Addendum No.: 1

Date Of Addendum: June 22, 2017

**Phase II Expansion of the
Middletown State Veterans' Cemetery
317 Bow Lane
Middletown, CT
BI – C – 293 / FAI No. CT-16-03**

drawing prepared by	DTC, INC. 2321 WHITNEY AVENUE, SUITE 301 HAMDEN, CT	date	5/24/2017
project	STATE VETERAN'S CEMETERY PHASE II EXPANSION MIDDLETOWN, CT	scale	
CAD no.	project no. BI-C-293 / FAI CT-16-03	drawn by	BP
		approved by	JP
		drawing no.	SKE.01

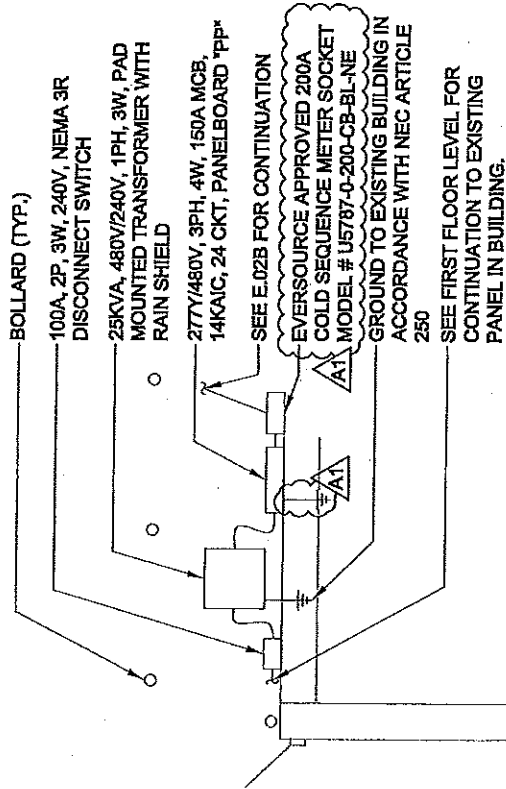
Drawing E.01 has been amended with sketch SKE.01 to show a cold sequenced 200A meter socket.

Note added to sheets E.01 and E.02B describing the use of wet listed cat 6 cables in exterior conduit as shown on sketches SKE.01 and SKE.02.

1. EXISTING 125A RATED GENERAL ELECTRIC PANELBOARD, 240/120V, 1PH, 3W, 100A MCB, 20CKT. REMOVE EXISTING BUILDING GROUNDING ELECTRODE CONDUCTOR AND ISOLATE NEUTRAL BAR.
2. EXISTING SQUARE D SUBPANEL 'SUB' FED FROM GE PANEL (60A CIRCUIT BREAKER), 240/120V, 1PH, 3W, MLO, 16 CKT, 10KAIC.
3. ALL LIGHTING TO BE WIRED THROUGH LIGHTING CONTACTOR. ALL CONDUIT AND WIRE TO BE CONCEALED IN THE BUILDING ABOVE THE CEILING. ANY EXPOSED CONDUIT SHALL BE PAINTED TO MATCH SURFACE.
4. CAMERA SYSTEM HEAD END UNIT LOCATION ON EXISTING DESK.
5. LIGHTING RELAY LOCATION.
6. ALL CAT6 CABLE TO BE LISTED FOR USE IN WET LOCATIONS.

drawing prepared by	DTC, INC. 2321 WHITNEY AVENUE, SUITE 301 HAMDEN, CT	date	5/24/2017
project	STATE VETERAN'S CEMETERY PHASE II EXPANSION MIDDLETOWN, CT	scale	
CAD no.		drawn by	BP
project no.	Bj-C-293 / FAI CT-16-03	approved by	JP
		drawing no.	SKE.02

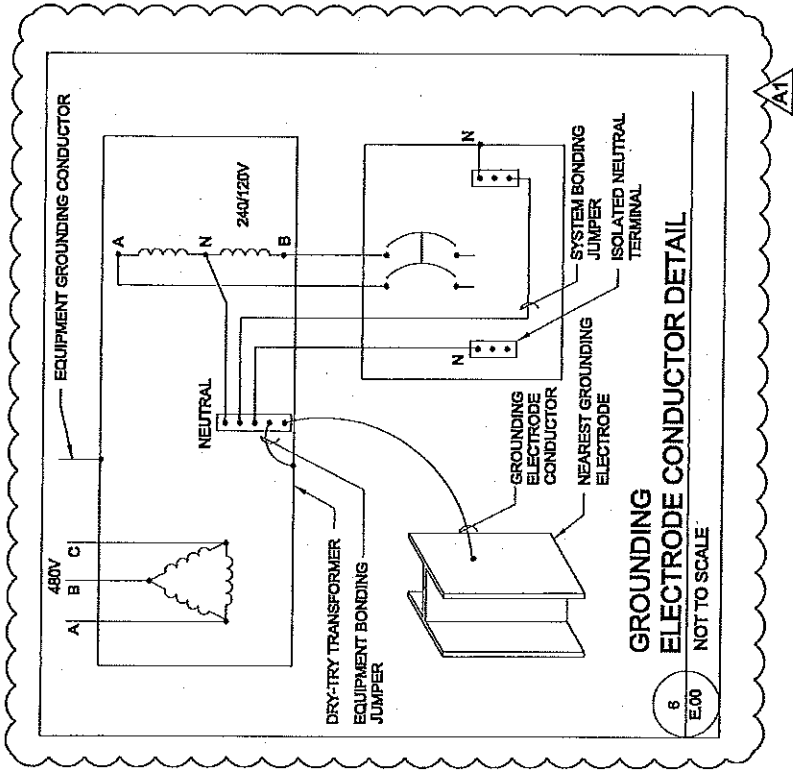
Grounding detail added to sheet E.00 as shown on sketch SKE.02.

Note added to sheet E.02B describing the use of wet listed above ground terminations as shown on sketch SKE.02.

Note added to sheet E.02B describing the use of wet listed terminations in hand holes as shown on sketch SKE.02.

1. ALL CAT6 CABLE TO BE LISTED FOR USE IN WET LOCATIONS.
2. ALL CONDUCTOR TERMINATING DEVICES USED IN SITE LIGHTING POLES AND IN HAND-HOLES TO BE LISTED FOR USE IN WET LOCATIONS.
